# LONDON BOROUGH OF ENFIELD PLANNING COMMITTEE Date: 2 February 2021 Report of Head Of Planning Contact Officer: Andy Higham Sharon Davidson Joe Aggar Tel No: 0208 132 0878 Application Number: 20/02461/CAAD Category: Other LOCATION: Oakwood Lodge, Avenue Road, London, N14 4DE (the "Site")

PROPOSAL: Conversion of existing roof space of each of the two residential blocks to provide a total of  $4 \times 1$ -bed self-contained flats and erection of dormer windows, skylights and alteration to external staircase (Application A) and;

Conversion of existing roof space of each of the two residential blocks to provide a total of 2 x 2-bed self-contained flats and erection of dormer windows and skylights (Application B).

# Ref: 20/02461/CAAD LOCATION: Oakwood Lodge , Avenue Road, London, N14 4DE

Project:
OAKWOOD LODGE DEVELOPMENT, AVENUE ROAD, N14 4DE
Drewing Title:
PROPOSED ROOF CONVERSION - PROPOSED REAR ELEVATION

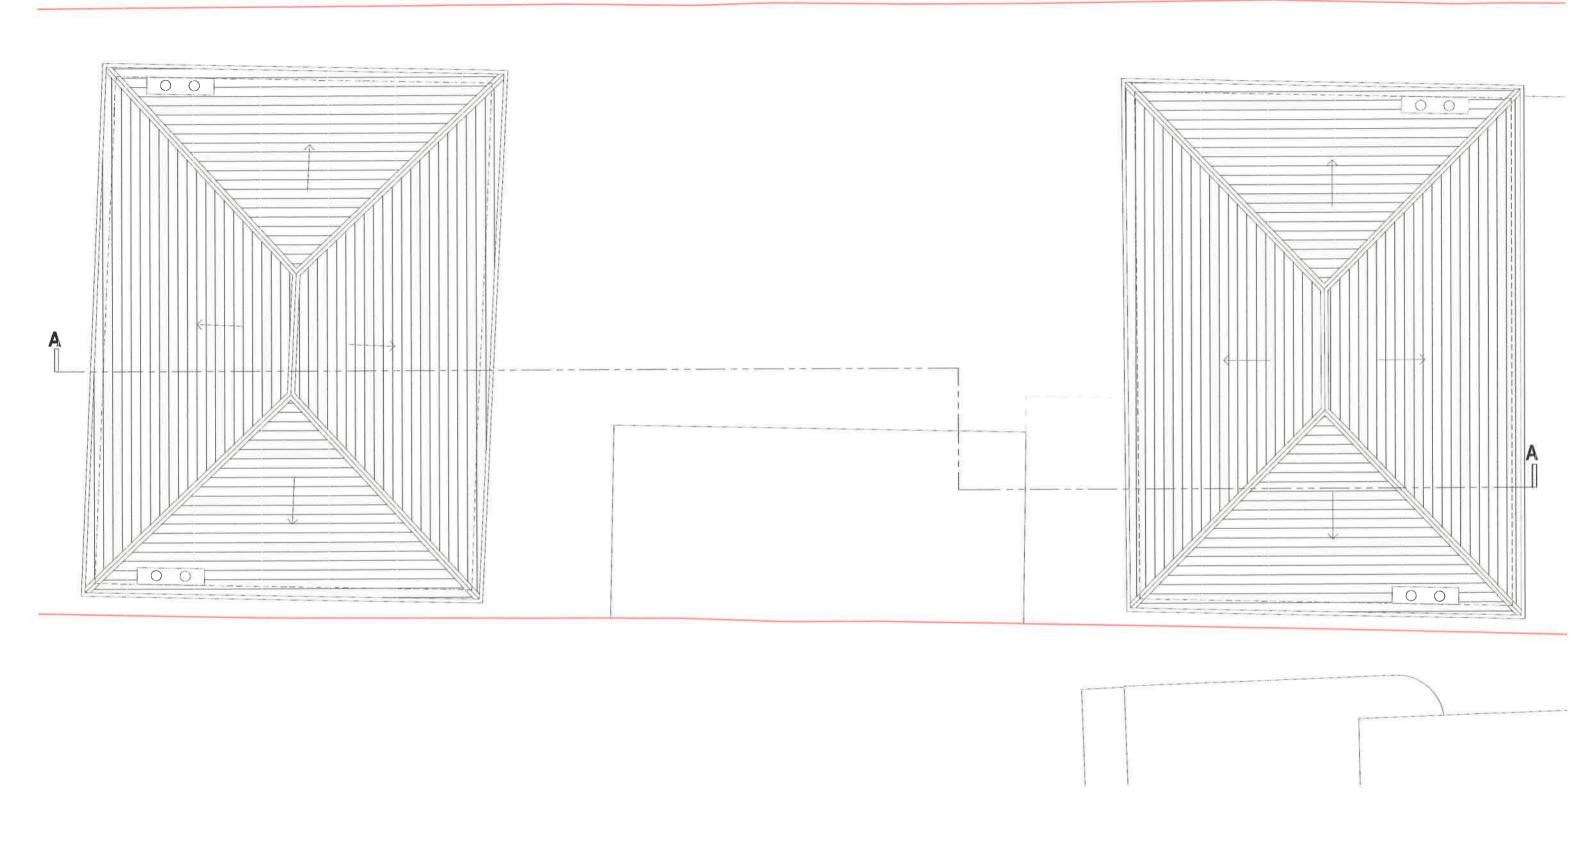
The proposed alteration to the roof form in Application A would considerably modify and dominate the roof slope to both buildings. The proposed dormers would be a large and incongruous modification, not in keeping with, and harmful to the character and appearance of the host buildings and the surrounding area. Overall, the alterations would have resulted in a highly conspicuous roof form, given their scale and elevated position relative to the adjoining properties.

The combination of the gable extensions and the larger front dormer windows would have significantly increased the bulk and mass of the building directly adjacent to the modest terraced properties. This discordancy would have been exacerbated by the windows to the roof extension which neither match nor align with the fenestration pattern to the lower floors. Viewed in combination, the proposed alterations at roof level, by reason of their size and bulk would have appeared as disproportionate and discordant additions to the original character and appearance of the host property.

Officers have therefore concluded that the proposed alterations within Application A would have had an unacceptably harmful effect on the character and appearance of the Site and the surrounding area. It would have conflicted with Policies 7.4 and 7.6 of the London Plan 2016, Core Policy 30 of The Enfield Plan Core Strategy 2010 and Policies DMD 8, DMD 13, and DMD 37 of the Enfield Development Management Document (DMD) 2014. Amongst other things, these policies sought to resist development that is inappropriate to its context or which fails to have appropriate regard to its surroundings. The proposal would have also conflicted with the NPPF which sets out that planning should always seek to secure high quality design.

Drawing Title:
PROPOSED ROOF CONVERSION - SECTION X-X
Date:
16.09.20 | Scale:
1:100 @ A3 | Drawing No:
568-103-P1

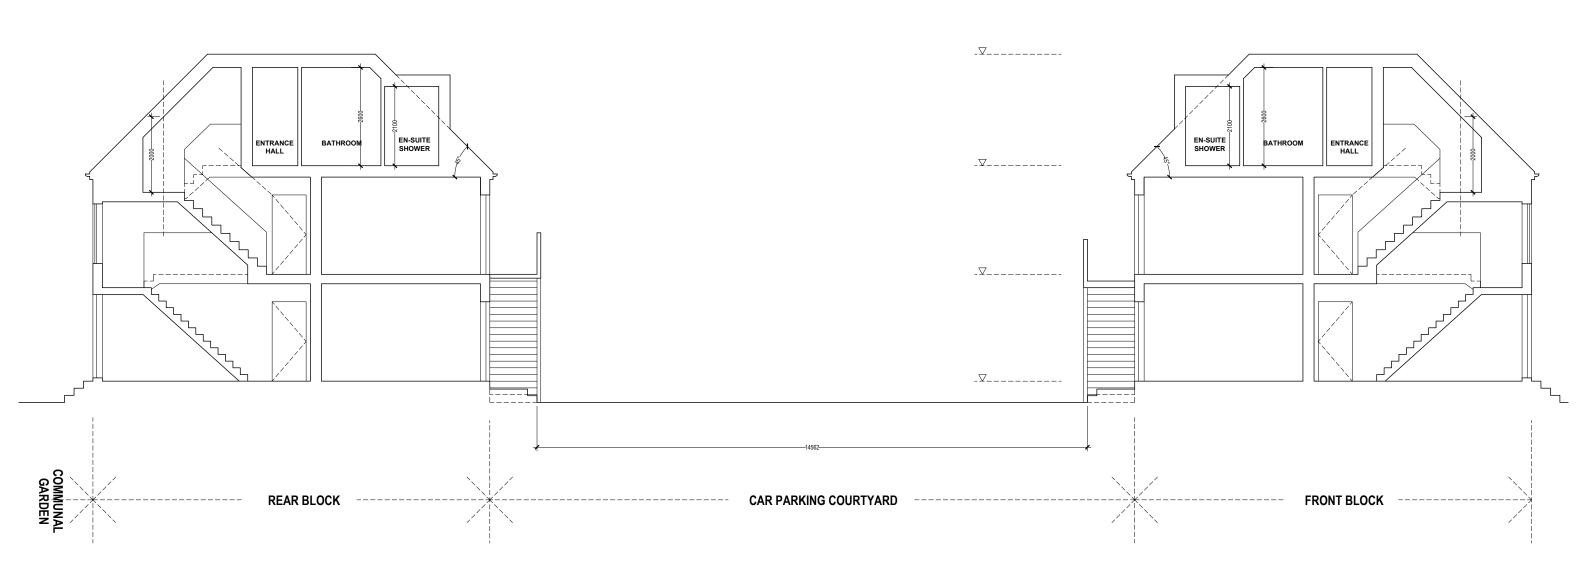
The maximum internal heights proposed in Application B, are 2.6m (towards the centre of the floor plan), dropping to 0.9m (close to eaves). The en-suite has a proposed internal height of 2.1m. Approximately 33sqm exceed the minimum requirement of 2.5m internal floor height, equating to 53% of the total floor area. The proposal would therefore fall below the recommended policy standard, which as stated, is expressed as a minimum. Whilst the shortfall would be small, the inadequacy in internal heights would result in a sub-standard living environment for potential future occupiers.
